CERTIFICATE OF THE SECRETARY OF ENERGY AND ENVIRONMENTAL AFFAIRS  
ON THE  
FINAL ENVIRONMENTAL IMPACT REPORT

PROJECT NAME : Centech Park North  
PROJECT MUNICIPALITY : Shrewsbury  
PROJECT WATERSHED : SuAsCo/Blackstone  
EEA NUMBER : 15950  
PROJECT PROPONENT : Town of Shrewsbury  
DATE NOTICED IN MONITOR : January 8, 2020

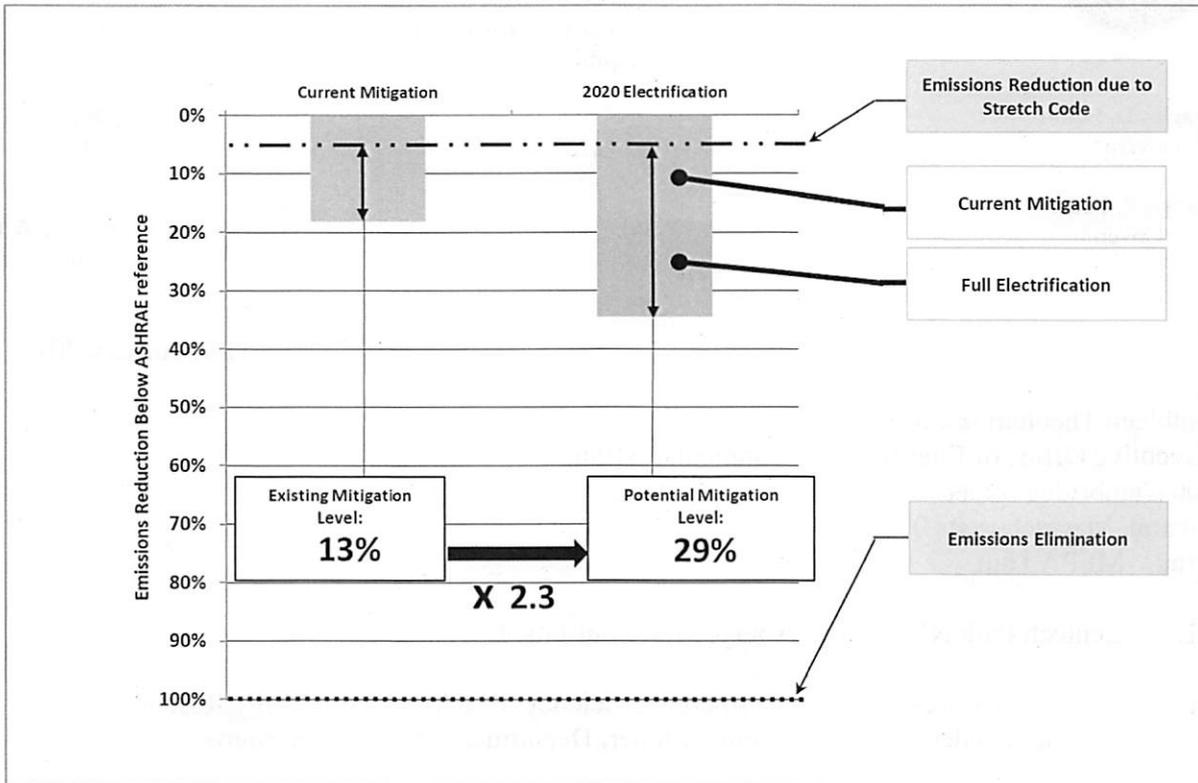
Mitigation Level could be improved to 29%, about a x2.3 increase, by fully electrifying space and water heating. We recommend full electrification. Full electrification would reduce emissions, reduce operating costs, and potentially qualify the project for Alternative Energy Credits worth about \$13,500/yr.<sup>2</sup> The currently-planned fossil fuel based systems will cost more to operate, have higher emissions, and wouldn't qualify for AECs.

The illustration below provides an illustration of the project's current and potential Mitigation Level.

- The currently-proposed (and committed) building efficiency strategies deliver a Mitigation Level of 13%.
- Fully electrifying space and water heating could more than double Mitigation Level to 29%.

- Replace currently-planned gas-fired equipment with cold-climate rated efficient electric heat pumps/VRF and commit to requiring cold-climate air source heat pumps for additional space heating.
- Replace currently-planned electric resistance water heating equipment with heat pump water heaters and commit to requiring heat pumps for additional water heating.
